MAYFLOWER PLATINUM

Details of Additions & Alterations

Flat No	606	Block no.	'A'
Flat Area	1800 sft	Type	Deluxe / Luxury
Buyer Name	Jagana Lokesh / Lalitha Kumari. P		
Phone No.	9963889378/ 9493404522(sasi)	Email	SasiBhushana.Jagana @Gmail.Com

Description	Direction	Owners & Developers :	Date :	18.03.2020	Promoted by
WORKING DRAWING OF FLAT.NO.A-6		Modi Properties Pvt Ltd.	Prepared By :		Modi Properties Pvt. Ltd Phone: +91-40-66335551
		Project Name & Phase :	Approved By :	Soham Modi	
		MAYFLOWR PLATINUM	Scale :	N.T.S

A6

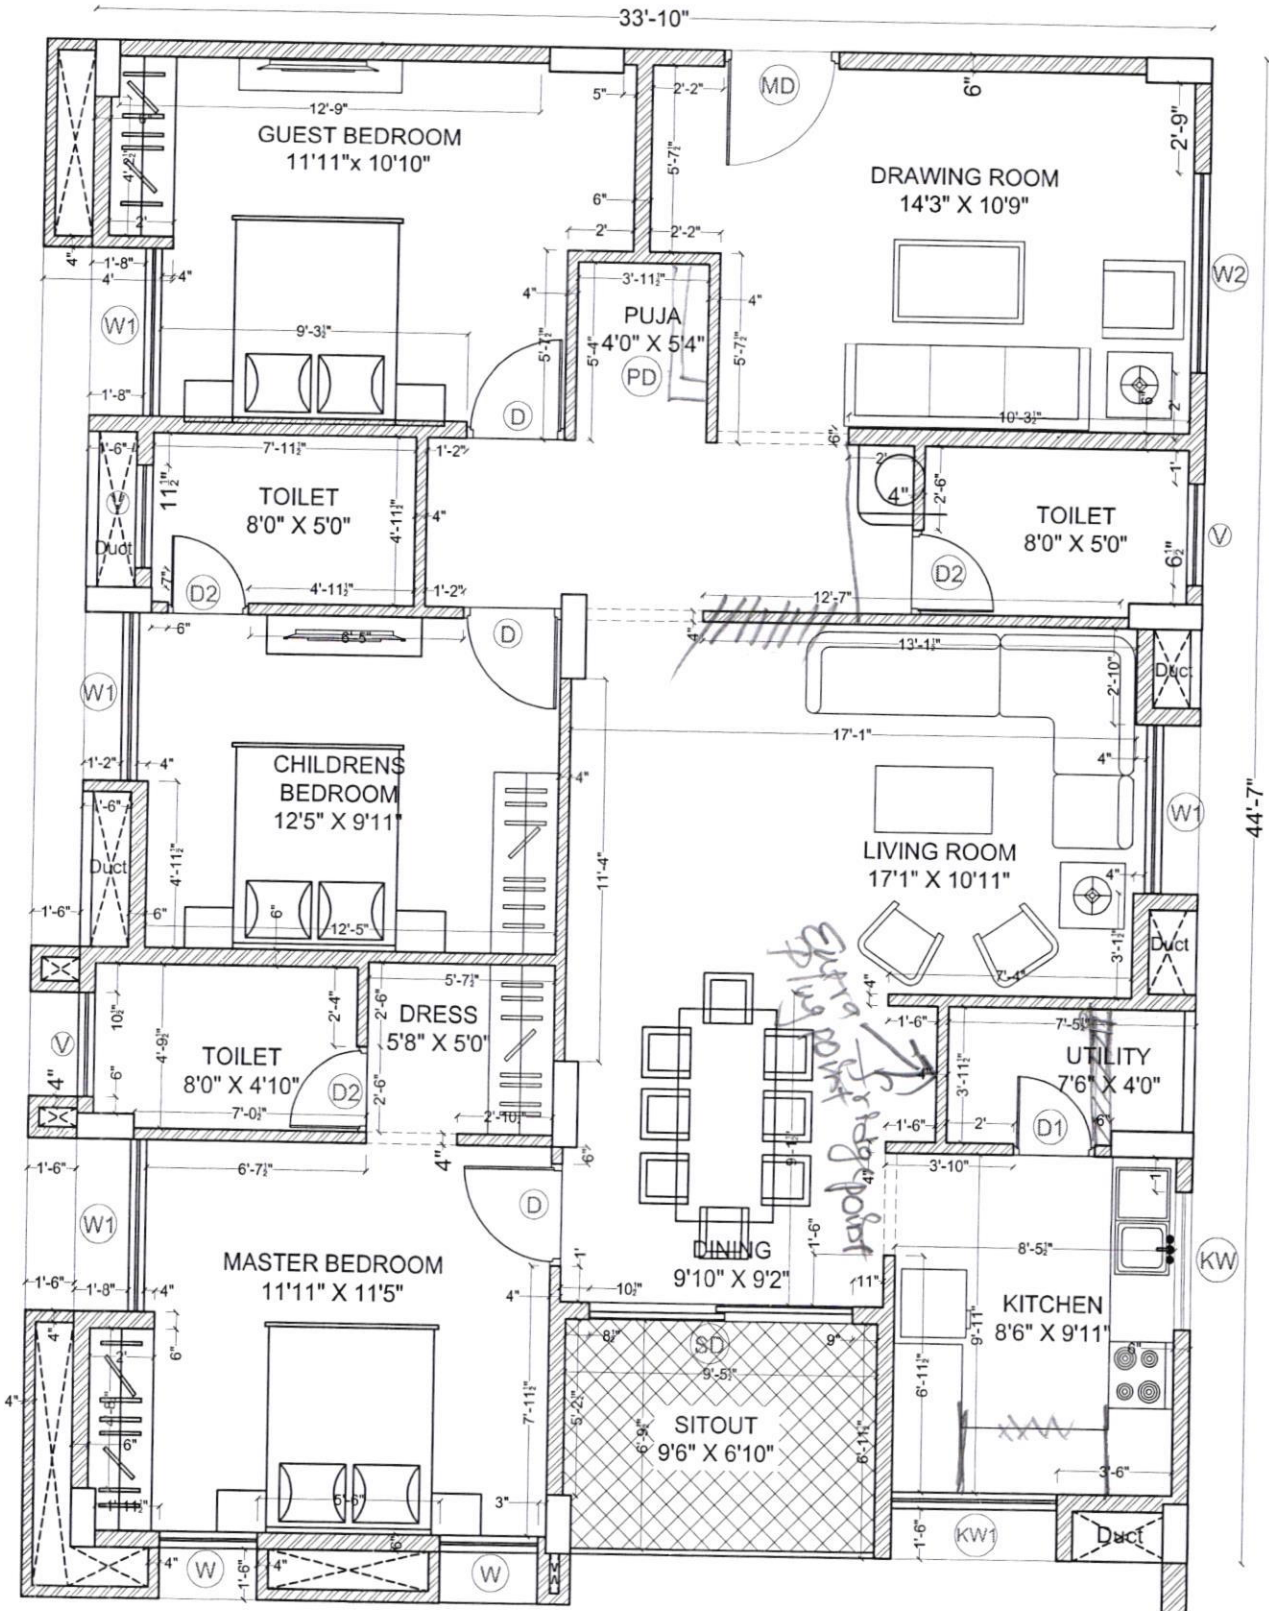
- ① Drawing, Living, dining ^{kitchen} area upgrade to big tile (TRAVELCON ROMANCEO) (As A-106 same) *
- ② MBR, CBR, LBR Same as CBR & LBR in A-106
- ③ Bathroom tiles Same as model flat.
- ④ Kitchen flooring Same as ^{living area} CBR & LBR in A-106
(240x240) Tiles. ~~MBR~~
- ⑤ MBR & CBR - wooden tiles as A-106
- ⑥ LBR - As in A-106

- ① Dining Area near wash basin 15amp pt required for refrigerator.
- ② Internet cable wire connection required in as per TV points. & Drawing room
- ③ 5amp pt in living area
- 4) Kitchen 2 extra 15-amps points
- 5) Dining internet cable laying to TV-point
- 6) 3 Bedroom 2 way switches

- ① Bathroom tiles same as A-106.
- ② Wash basin pt to be shifted outside common bathroom wall (marked on plan)
- ③ All Sanitary ware pure white colour.
- ④ Balcony place extra washbasin.
- ⑤ WC Shifted from west facing to South facing.

① Kitchen platform Granite U shape beside the Switch
Geared.

② Balcony railing with glass.

③ Extra wall at utility upto 4" height (Marked on
plan)
